**Proposal #24: 4616-03-71, WISC 2021 092
T Wrightstown, CTH ZZ
Clay Street – Mallard Road
CTH ZZ
Brown County**

This is Addendum No. 01, which provides for the following:

ADDENDUM NO. 01

4616-03-71

Addendum No. 01
ID 4616-03-71
Revised Sheet 81
December 14, 2020

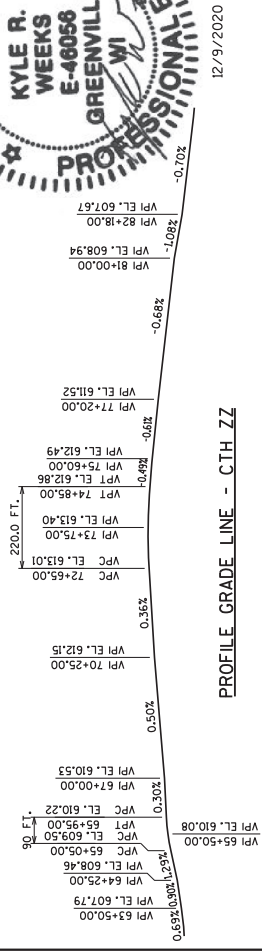
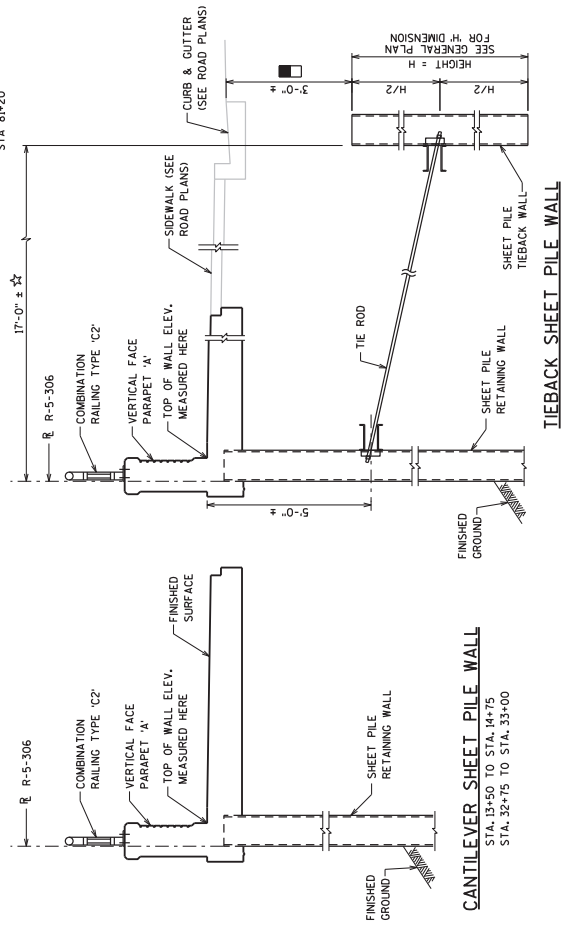
Revised Plan Sheets	
Plan Sheet	Plan Sheet Title (brief description of changes to sheet)
81	Wall Details R-5-306 Sheet 3 of 12 – removed note with incorrect section modulus.
